Rampion 2 Offshore Windfarm – EN010117
Interested Party Reference – 20045298

The South Downs National Park Authority (SDNPA) response comprises detailed comments in respect of:

Response from the South Downs National Park Authority to the Examining Authority's written questions and requests for information (ExQ1)

Rampion 2 Offshore Wind Farm
 Figure 16.4 Seascape character
 Preliminary Environmental Information Report

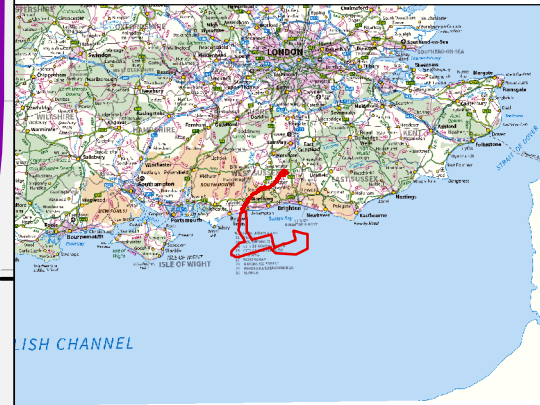
- 3.2. It is important to note, as the SDNPA, 2021 report states, that, in designating the area, the Inspector left the maritime boundary of the National Park open. In our view the SDNPA, 2021 report seascape zone boundaries (especially SCZ01) better reflect this sentiment in considering wind turbine development than the boundaries of MCA 08 (which do not reflect static features on the sea surface or the boundaries of likely visibility of structures). Nevertheless it is recognised MCA 08 is a valid receptor to consider as part of the Marine Plan evidence base.

- 3.3. The assessment of effects on the following seascape character zones should be undertaken: SCZ01, SCZ02, SCZ04, SCZ05, SCZ06.
- 3.4. The consideration of the SLVIA findings and a preliminary assessment of the effects on the seascape zones derived from the SDNPA, 2021 study are set out in the following pages. For reference, the MCAs assessed within the SLVIA and the seascape zones in the SDNPA, 2021 study are copied into this report overleaf.
